MFN 06-262
Supplement 4

Subject: **Modified Reactor Building/Fuel Building Truncated Model,
SER-ESB-038 Rev. 5**

**Shimizu Engineering Report SER-ESB-038, Rev. 5,
“Modified RBFB Truncated FE Model Analysis Data,”**

Project	General Electric Company ESBWR Project	Shimizu Document No.	SER-ESB-038
Title	Modified RBFB Truncated FE Model Analysis Data	Rev.	5
		Issued Date	9/22/06
		Revised Date	1/9/07

Figure C-3 Element Forces Comparison NASTRAN to ANSYS (RA FA Wall: Out-of-plane Shear [MN/m])

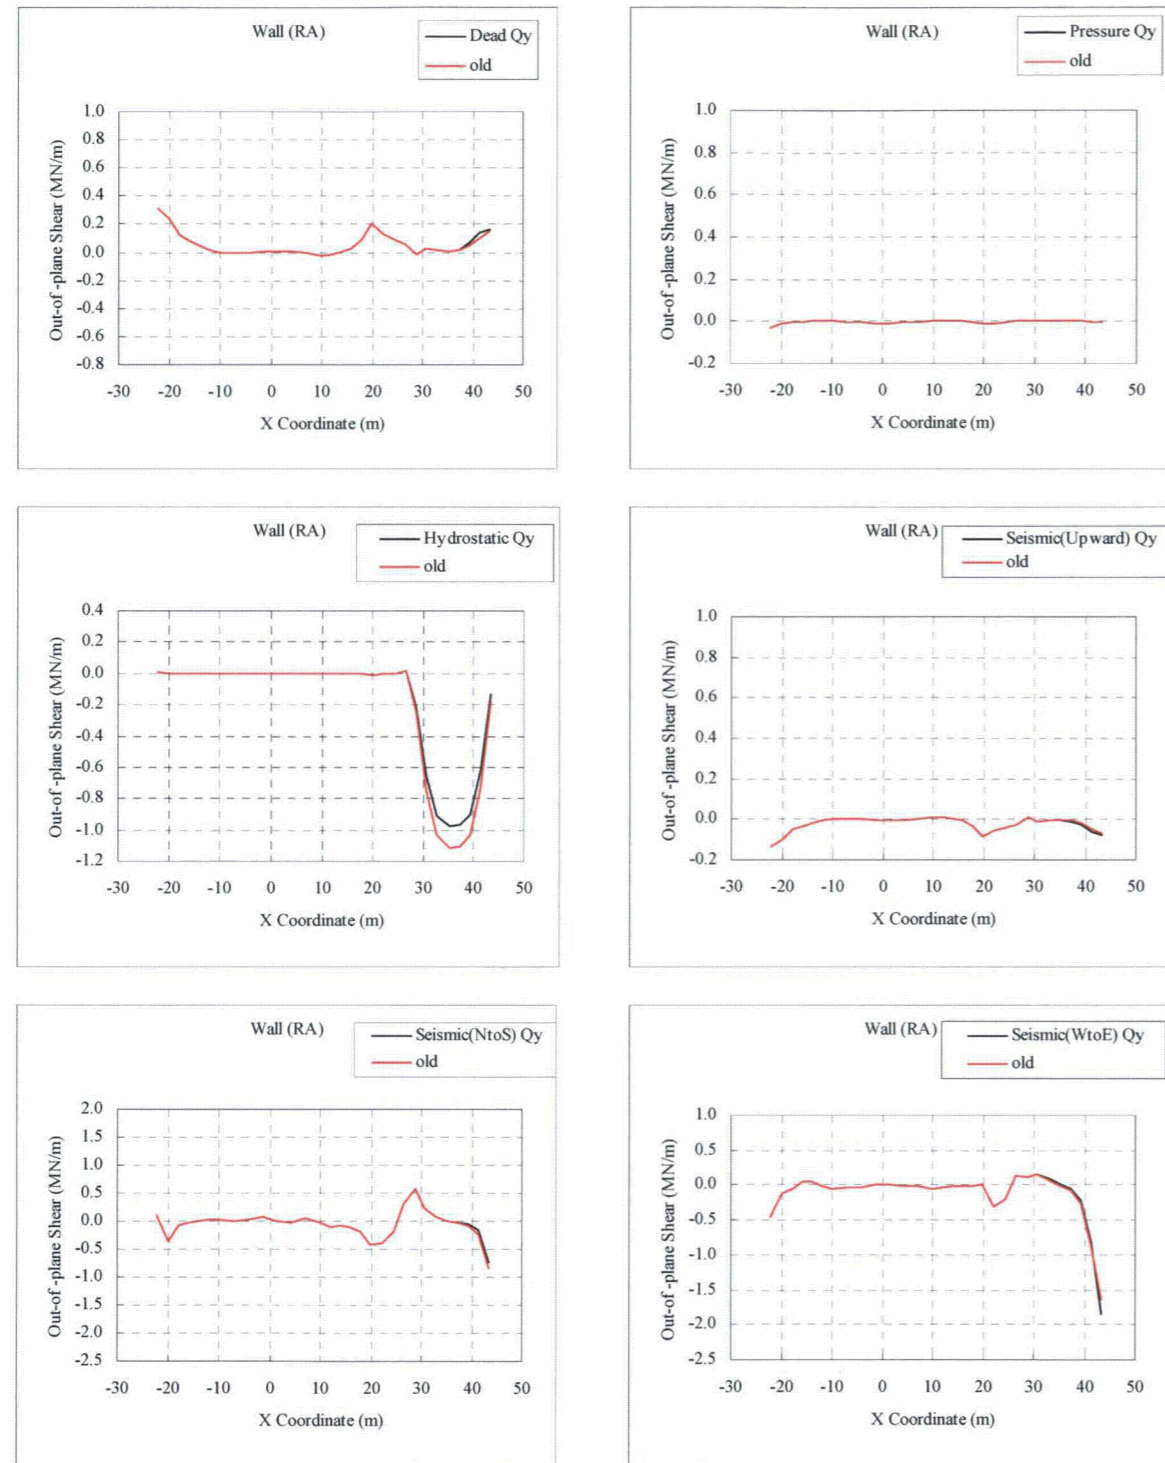
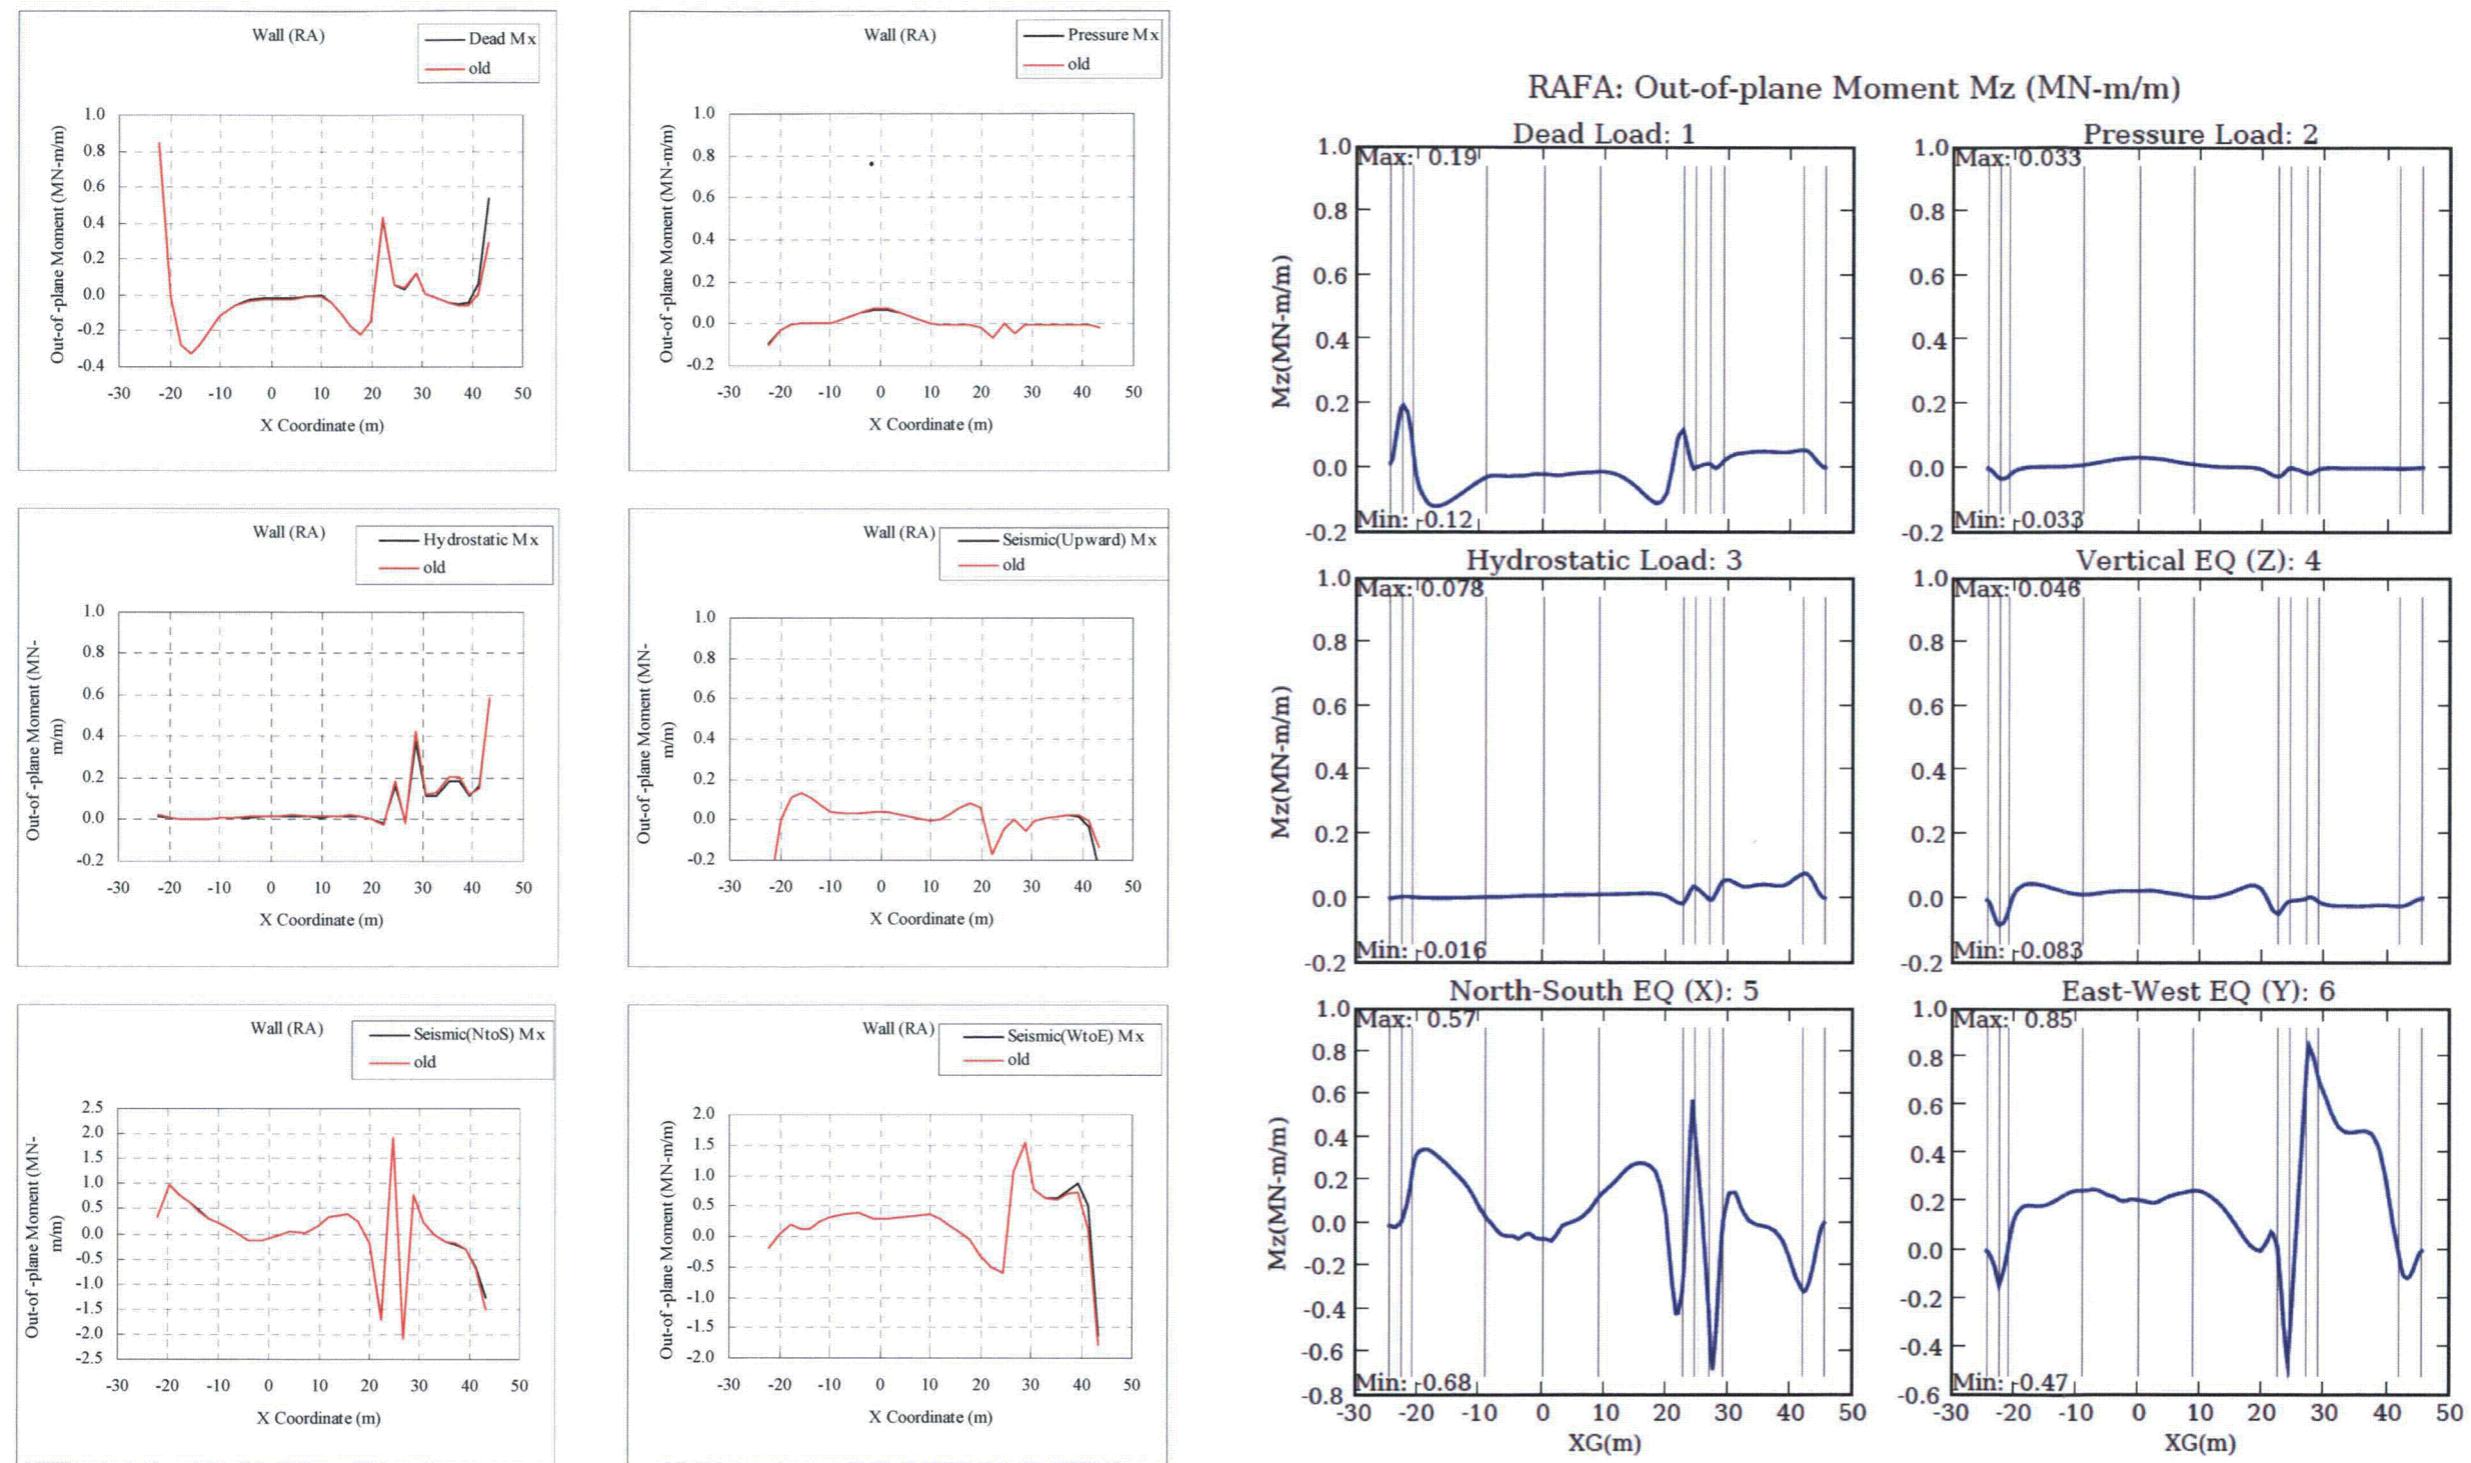
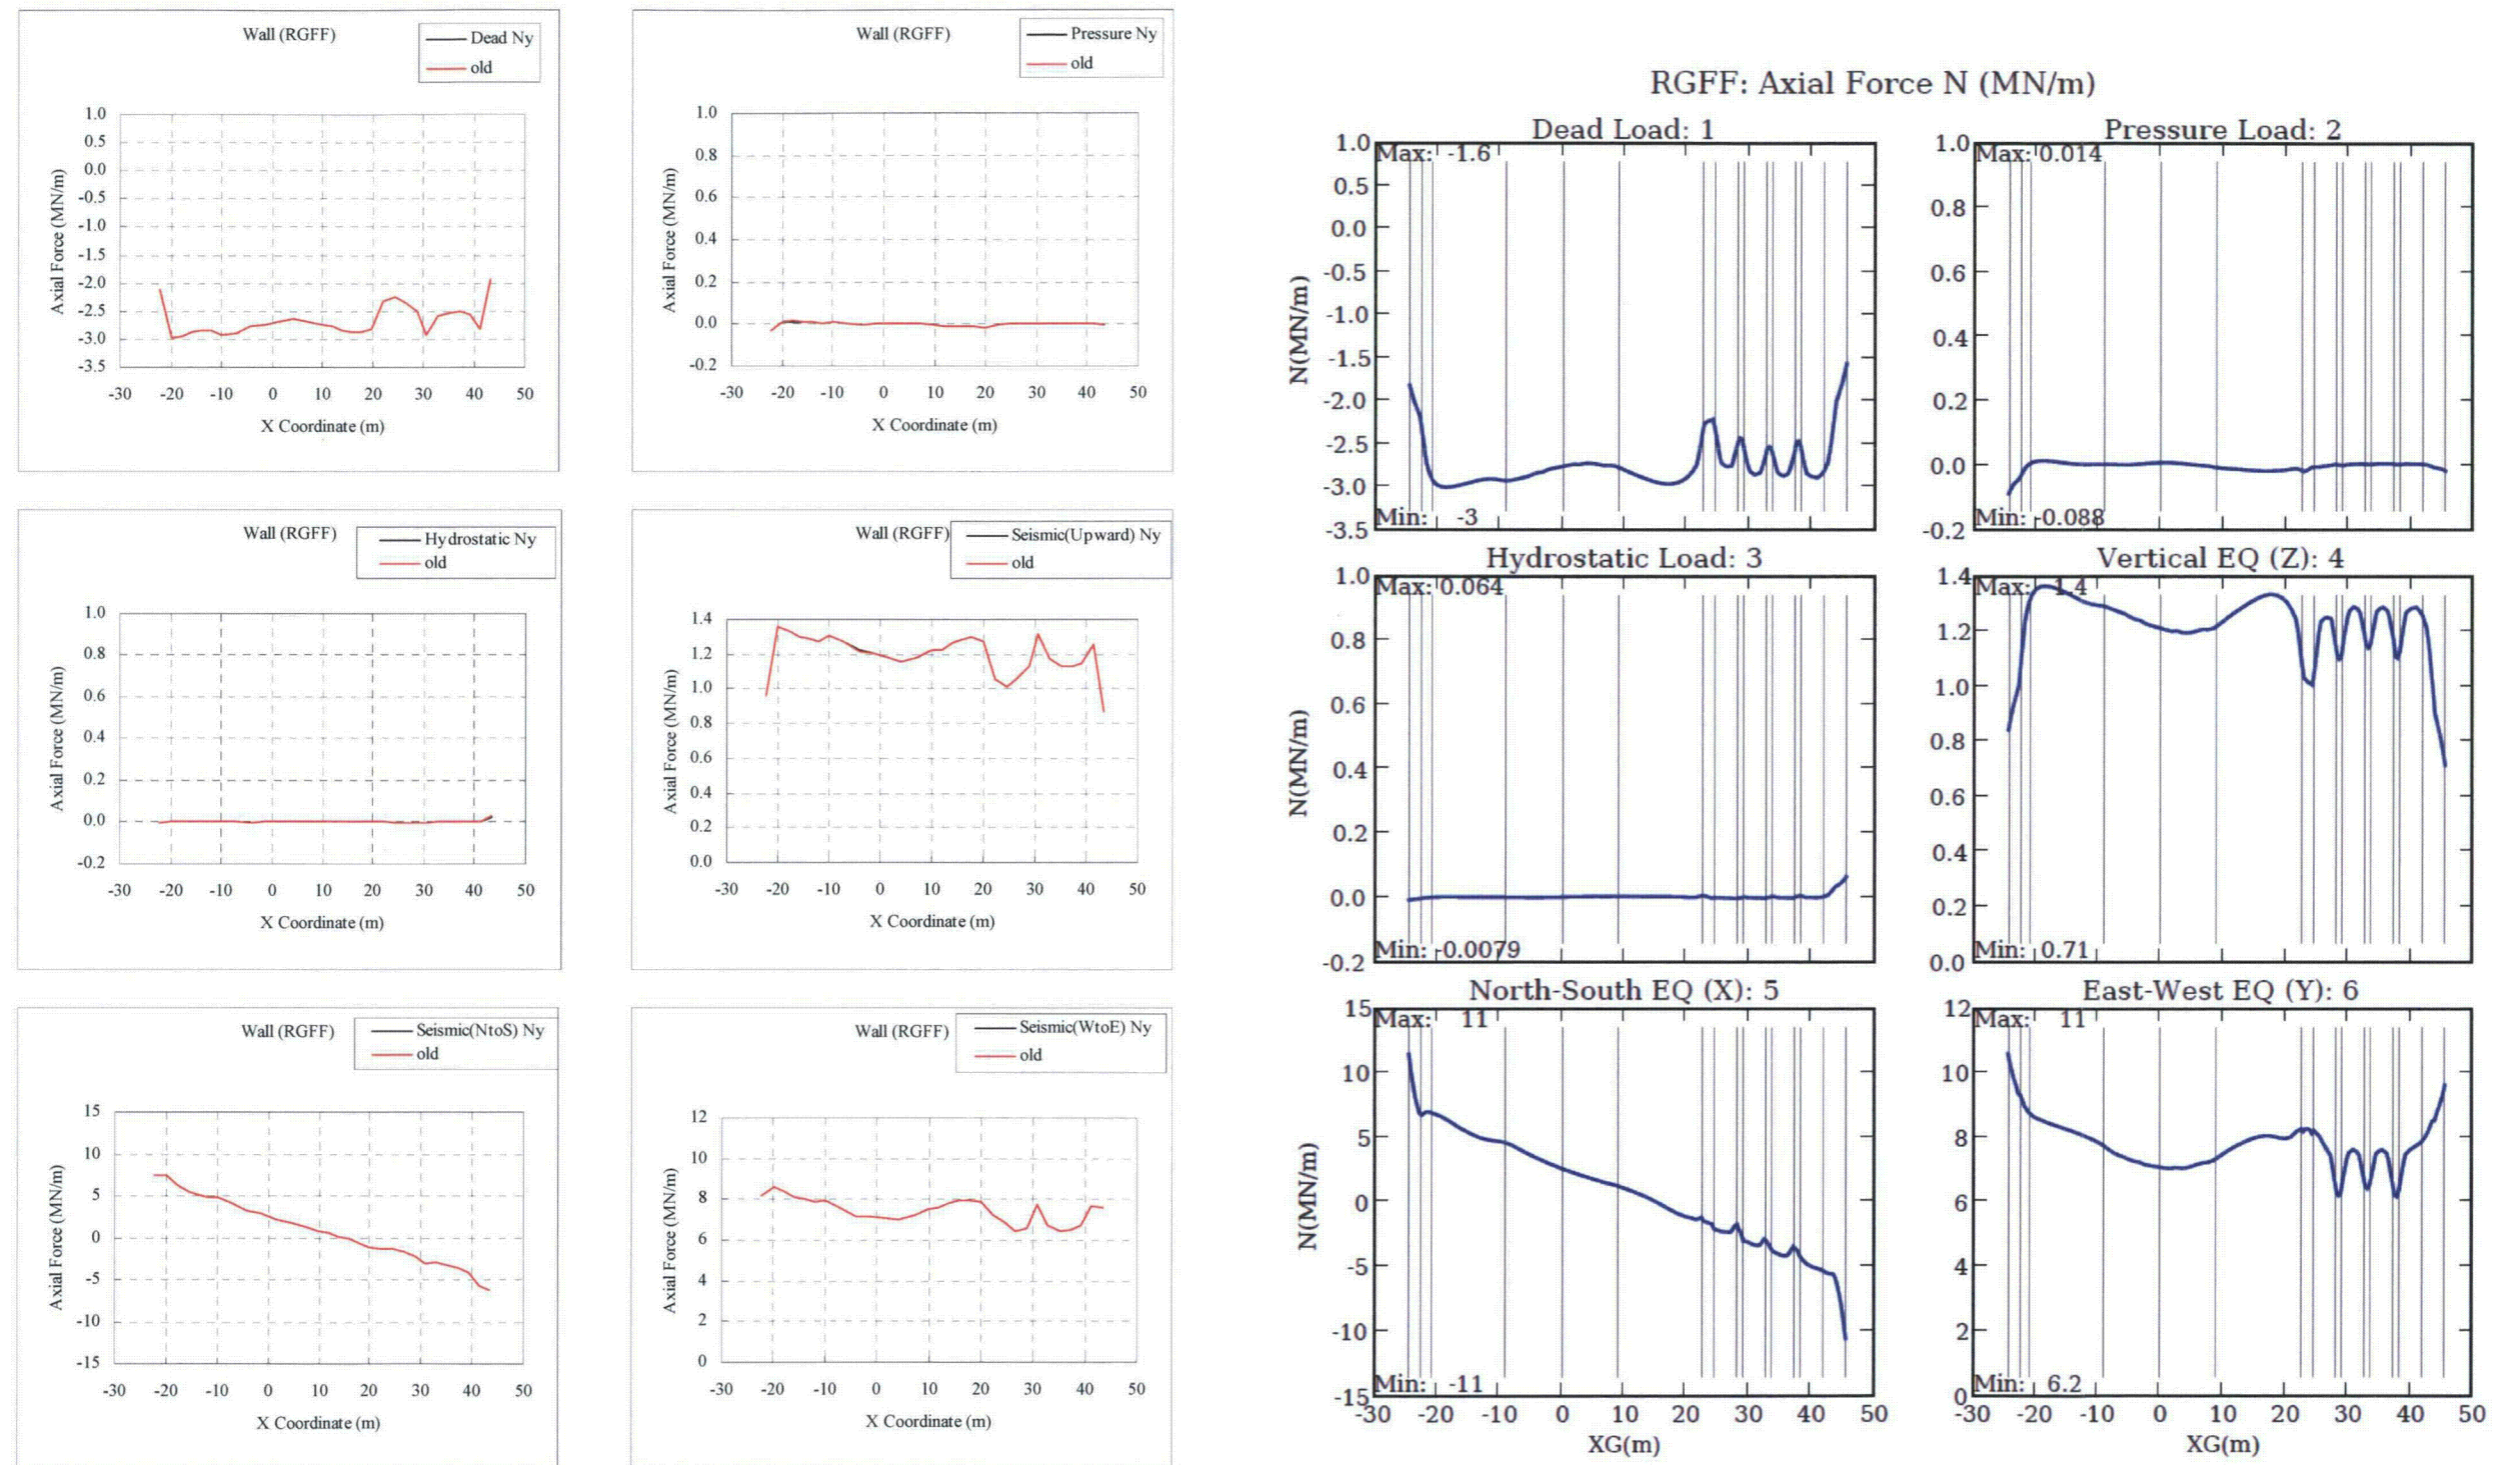
- iii) *The differences of magnitude of forces appeared on basemat inside pedestal:* The result of re-analysis using the updated model shows better agreement. In case of seismic load the magnitude of forces has to be re-compared because BNL's soil spring may not be adequate as pointed out above 3).

- iv) *The differences of magnitude of forces appeared on outer wall of Fuel Storage Pool (FSP):* For the out-of-plane shear forces and moments on RA and F3 wall located around FSP in case of Hydrostatic load, BNL's results are lower than those of GE. GE assumes the some part of differences comes from the difference of estimation levels between both models as pointed out above 8). In order to have a better understanding of the differences, GE would like to request BNL to confirm the input data for Hydrostatic load.
